UNITED STATES PATENT AND TRADEMARK OFFICE

10/595,196

Office Action Summary	Application No. 10/595,196	Applicant(s) GELARDI ET AL.	
	Examiner ERNESTO A. GRANO	Art Unit 3728

DETAILED ACTION

FIG. 1
(examiner modified)

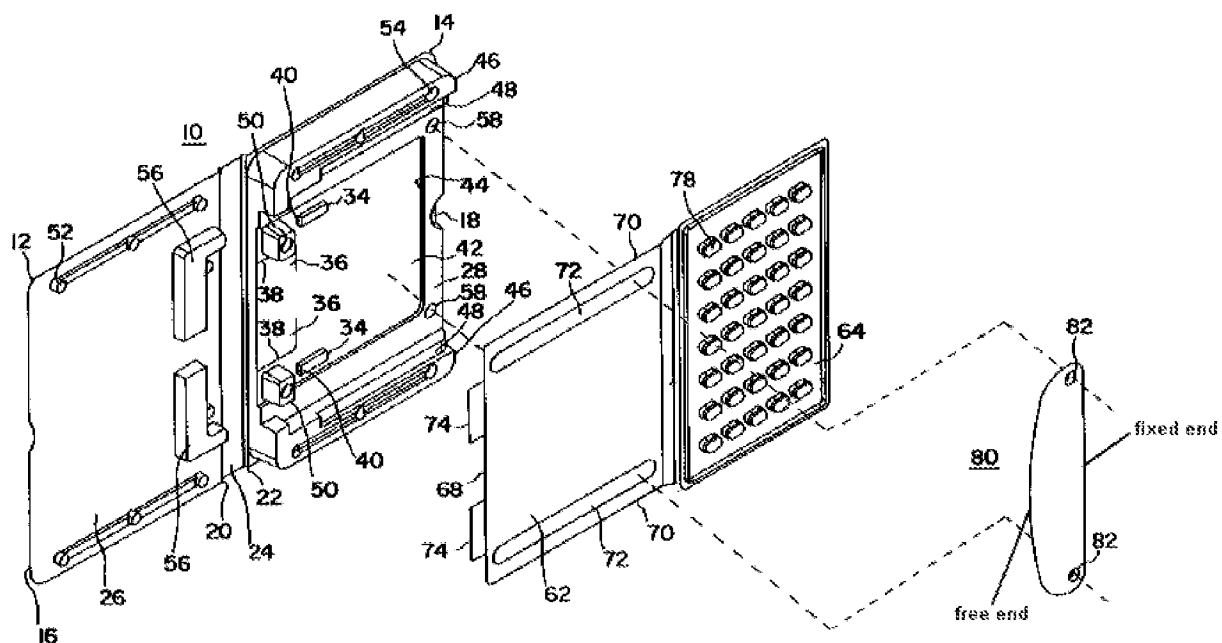
In re claim 1, with reference to figures 1 and 8, Buss ('831) discloses a storing and dispensing system, comprising:

- a case (10) and a slideable card (64) holding items to be dispensed

- said card (64) comprising at least one detent receiver (74) and at least one retainer receiver (72)
- said case (10) comprising:
 - a first side (12) matingly connected to a second side (14) to form a void capable of receiving said card (64) opposite closed edges and a dosed end (24) formed by said mated connection and further defining said void

- an open end opposite said dosed end (24) configured to permit said card (64) to translate between a first position (closed) and a second position (opened)

- at least one detent (34) extending from one of said sides (14) toward said void for engaging said detent receiver (74)
 - a release proximate (36) to said detent (34) configured to disengage said detent receiver (74) and said detent (34)

- a retainer (80) located within said void having a fixed end and a distal free end, said free end configured to engage said retainer receiver (72) and interrupt the separation of said card (64) from said case (10) (see column 4, lines 54-64)

- wherein said retainer (80) capable of being configured to permit said free end to be disengaged from said retainer receiver (72) by a replacement card

- whereby engaging said detent (34) and said detent receiver (74) locks said card (60) within said case (10), and manipulating said release (36) to disengage said detent (34) and said detent receiver (74) unlocks said card (64)

In re claim 14, with reference to figure 1 above, Buss ('831) discloses a blister card for use with a child-resistant blister card receiving case (10), comprising:

- a first side (1st) having a plurality of pliable blisters (78) configured to receive medicaments (90) (see figure 8)
- one medicament positioned (90) (see figure 8) within at least one blister (78)

- a breakable sealant affixed to a second side (2nd) and securing said medicaments (90) in said, respective, blisters (78) (see column 5, lines 14-16)
- one detent receiver (72), capable of being configured to engage a detent (34) of a case when said card (64) is in a first, substantially received position (closed)
- one retainer receiver (72), capable of being configured to engage a retainer (80) attached to a case when said card (64) is in a second substantially extended position (opened)
- wherein said blisters (78) are capable of being positioned to permit said card (64) to slide between said first and second positions (closed and opened).
